FINAL DRAFT MINUTES

November 16, 2012 Standards Committee Meeting
(Changes that are made to the First Draft are shown as highlighted in teal)

RE: Minutes from the November 16, 2012 Standards Committee Meeting

Picture 1

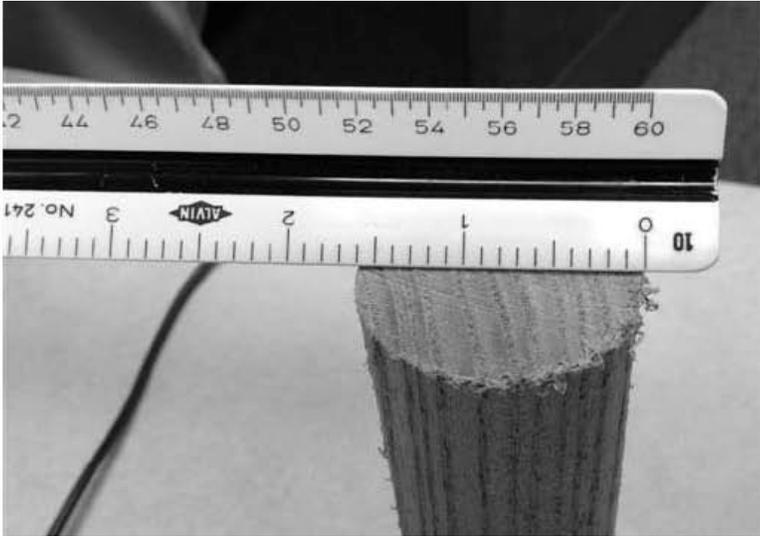
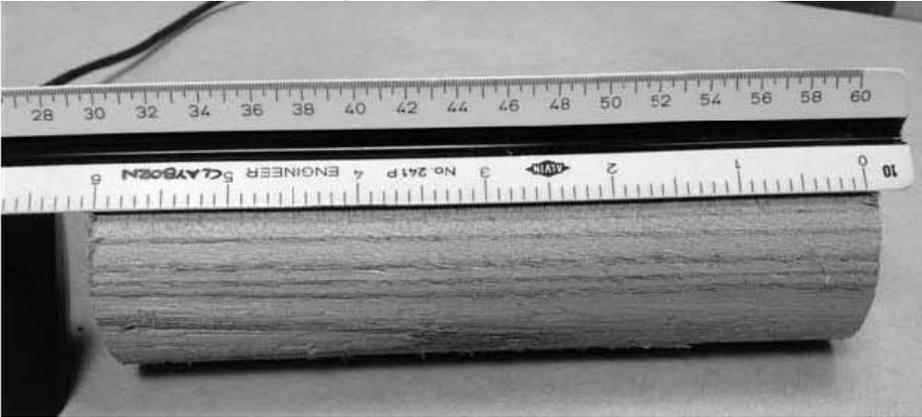
PROBLEM(S) ENCOUNTERED: To date, I have heard of underseal material migrating upwards on three active contracts to include the US-40 project west of Greenfield. Standard Specification section 612 states:

This should be the end of the story but as of recent it has not been. We know the undersealing operations have/are occurring before milling operations. We know the historical material used has been UA-III but recent projects have been using UA-II (less viscous) due to supply issues with UA-III. The UA-II material can be 4 times more ductile and approximately 1.5 times softer at higher temperatures than the UA-III. Tommy Nantung's assessment that UA-II is the wrong material for use in undersealing operations is probably correct but should be irrelevant assuming the drilled holes were properly sealed. Some drilled holes are being properly sealed as evidenced by only a percentage of them displaying visual evidence of actually leaking. I believe milling the pavement after the drilled holes are plugged is the primary cause for the observed problem; the secondary cause is the UA-II material. Hypothesis: the wooden plugs are damaged to an extent they no longer afford a reliable seal to prevent the UA-II material from migrating upwards; the underseal material lacks the physical qualities to resist the upward migration.

The current specification in 612 does not account for the milling operation.

PROPOSED SOLUTION: Require an inspection of all wood plugs upon completion of milling and before overlaying with HMA pavement. Damaged or loose plugs should be replaced.

BACKUP 02 EXISTING DRAWING 720-MHCA-02 MANHOLE CASTING TYPE 4 RING AND COVER

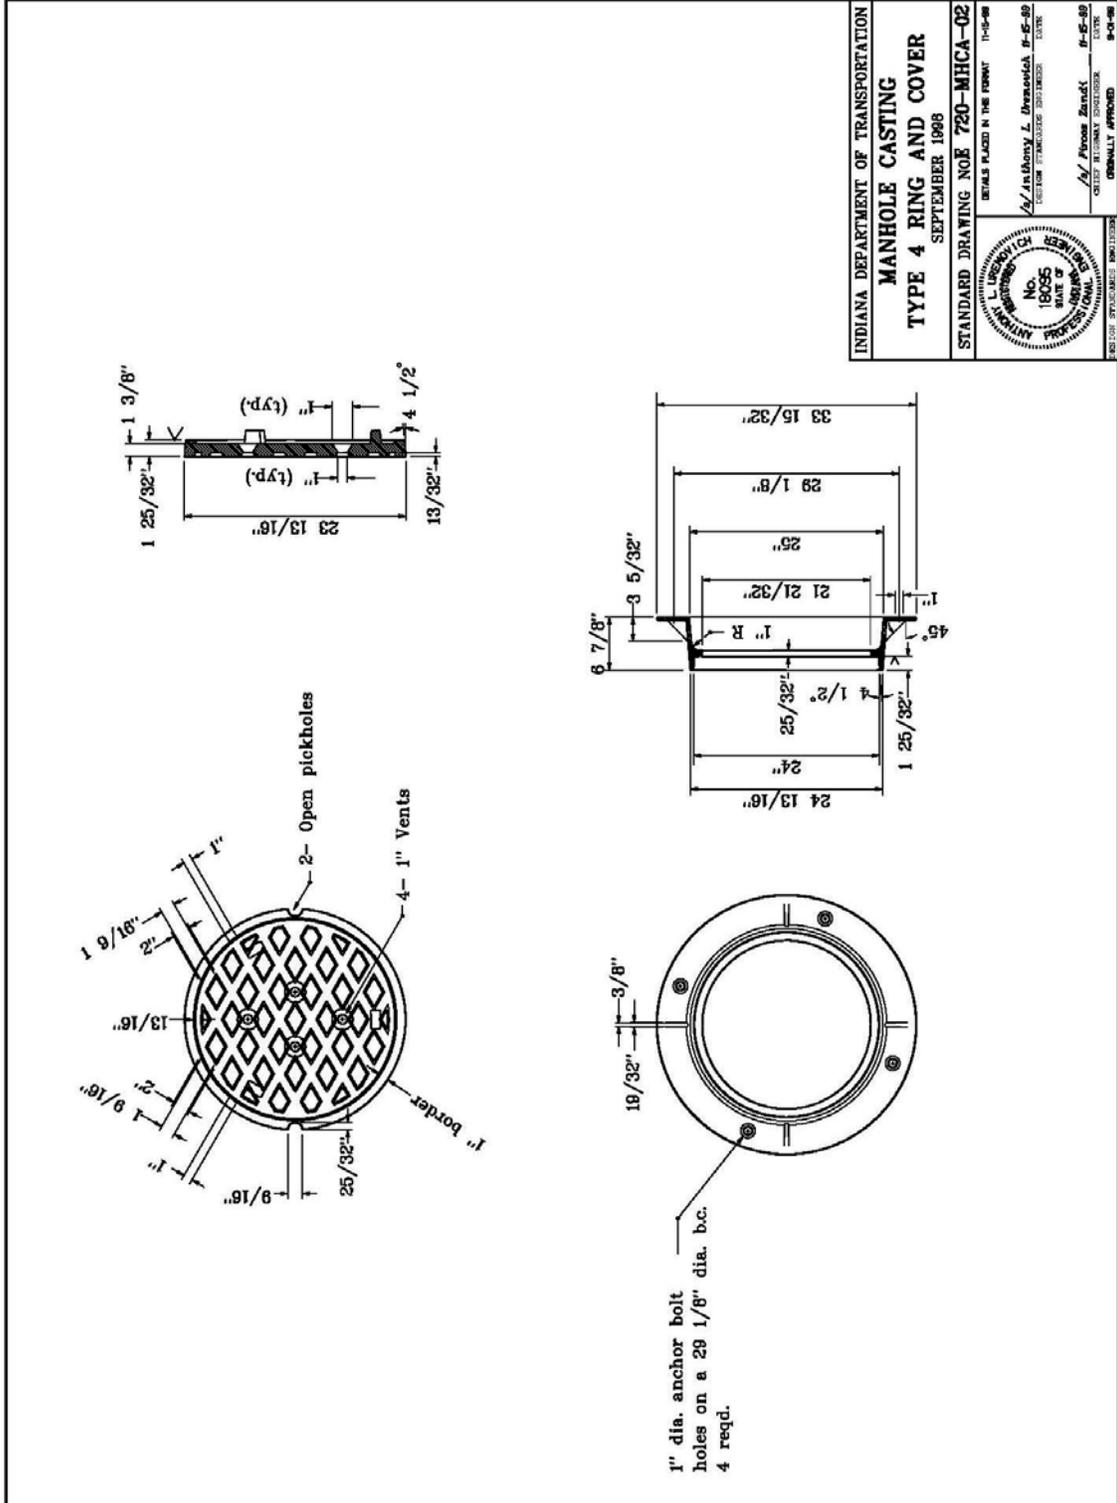
DISCUSSION: Presented by Ms. Phillips as described on the proposal page. Mr. Keefer mentioned that the lids with the smaller openings are also of a smaller diameter, so would not be interchangeable with the lids in question. Mr. Miller asked if this could be resolved by a design memo. Mr. Keefer suggested it be a separate item for ADA/sidewalk applications. Mr. Vancleave agreed. Ms. Phillips asked if a supplemental description would be enough.

John Crist of East Jordan Iron Works suggested modifying their Type 4 cover to fit this application. Also the diamond pattern on the Type 4 is quite aggressive. Mr. Crist suggested a different frame set altogether that has smaller vent hole and the diamond pattern is less aggressive.

PROBLEM(S) ENCOUNTERED: With the ADA regulations it is recommended that castings not be placed in an area that pedestrians can walk. Many times a casting cannot be relocated to outside of this area. The castings used within a sidewalk or pedestrian area are typically a flat top lid. The current INDOT standards for a flat casting on a manhole is meant for placing this only in a pavement area and is not conducive to a pedestrian environment. A flat castings is needed that can also be placed within an area that pedestrians navigate. The current INDOT design guideline states the following:

Gratings should not be placed within the walking surface. If, however, gratings are located in the walking surface, they should have openings of not greater than 1/2 in. in one direction. If gratings have elongated openings, they should be placed so that the long dimension is perpendicular to the dominant direction of travel.

PROPOSED SOLUTION: Provide a casting detail for use within a sidewalk that does not violate the opening greater than 1/2". This standard would be added to the other standard castings and be identified to use within a sidewalk or pedestrian area.

APPLICABLE STANDARD DRAWINGS: This would require a new standard drawing or add to the current E-720 MHCA-03 detail.
